TVA-SQN-TS-92-01

SEQUOYAH NUCLEAR PLANT (SQH) - RESPONSE TO QUESTIONS ON REQUEST FOR
LICENSE AMENDMENT TO TECHNICAL SPECIFICATION (TS) - SPENT FUEL POOL
STORAGE CAPACITY INCREASE

On September 1, 1992, we received questions from NRC concerning the structural integrity analysis of the proposed spent fuel storage racks. The enclosed pages provide TVA's response to those questions.

WELD STRESSES BETWEEN CELL AND BASEPLATE

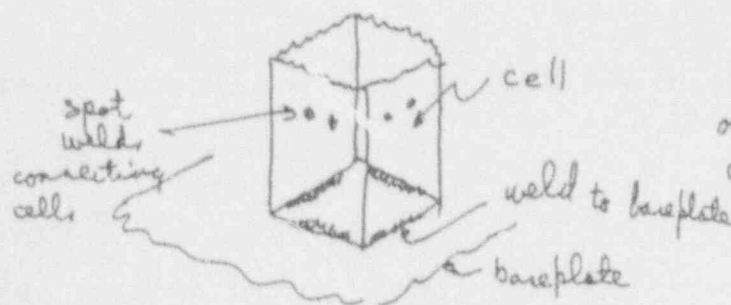
Discuss the stress analysis of the various welds described in Page 6-28 and 6-29. Provide a definition of the limit force and the moment together with a numerical example of weld stress analysis of baseplate to rack and cell to cell. In particular, expand the term function (F/F_y, M/M_y).

A copy of annotated back-up calculations for the welds is attached. These computations were performed using MathCad (commercial calculation program) and show how final results reported in the licensing document were achieved. The limit analysis interaction formula is

where F, M are applied compressive force and net bending moment applied to a J-weld section, F_y = limit force = W_y A_w and M_y = limit moment calculated on basis of ideal plasticity with W_y = yield stress and A_w = weld effective stress area. Use of a straight line interaction formula implied by the foregoing equation is conservative, as it neglects the gussets in the calculation of plastic section moduli.

Let c be cell width, t be cell thickness, l_w be weld length per side of cell, t_w be weld size. Assume welding on 4 sides.

R_6 value allows one to calculate stress in cell wall. Stress in weld is obtained by ratioing cell area to baseplate weld area.

This is less than the allowable weld shear stress.
 For faulted conditions, we use .42 x ultimate stress
 as the shear limit per ASME NF which refers you to Appendix D
 for dealing with faulted conditions. Note that this weld stress is less
 than the weld stress allowable from the NF table for normal operation.
 (21000-24000 psi)
